**PARTS & SERVICE
NEWS**

REF NO.	AT00271
DATE	Dec. 18, 2000

SUBJECT: REPAIR OF OIL SEAL FOR ALTERNATOR FPTO DRIVE ON 6D170 ENGINE

PURPOSE: To introduce modification procedures to repair oil leakage occurring through the oil seal in alternator drive and in FPTO drive of 6D170 engines

- 1) Oil seal for the alternator drive

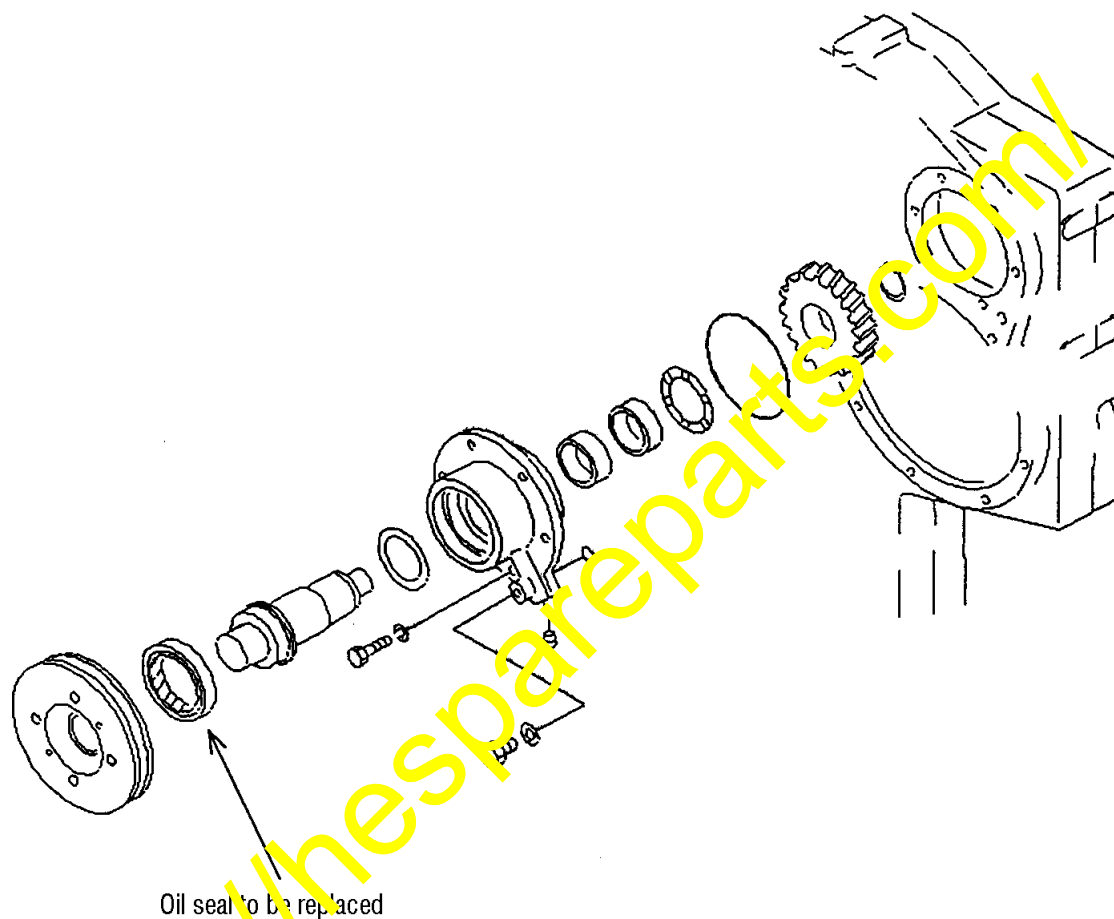
Part number	Conventional part		Modified part
	6162-63-1681	6162-63-1682	6162-63-1683
Structure	Oil seal lip + Single dust lip	Oil seal lip + Double dust lip	←
Material	Silicon	←	Fluorine
Modified time	—	The year 1998	This time
